**Change**

The latest replacement standard pistons (P/N 735-9686) for these engines use a different set of piston rings. The latest piston's oil ring groove is not as deep as the older piston.

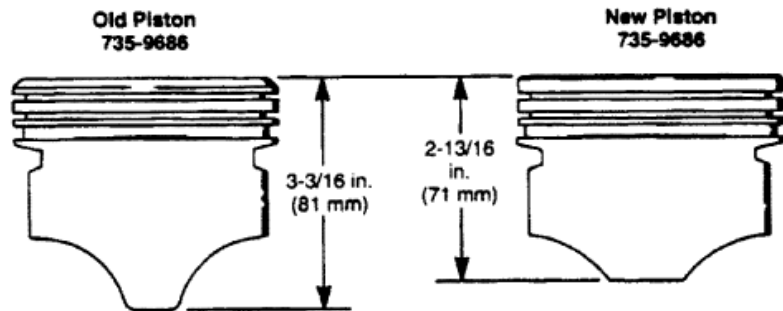
If piston rings only are required, refer to the drawings before ordering replacement piston ring sets from the chart.

The latest replacement piston will be shipped with a set of piston rings.

Model	Old Piston P/N 735-9686 Ring Set	New Piston P/N 735-9686 Ring Set
5.7L	39-17464	39-801861
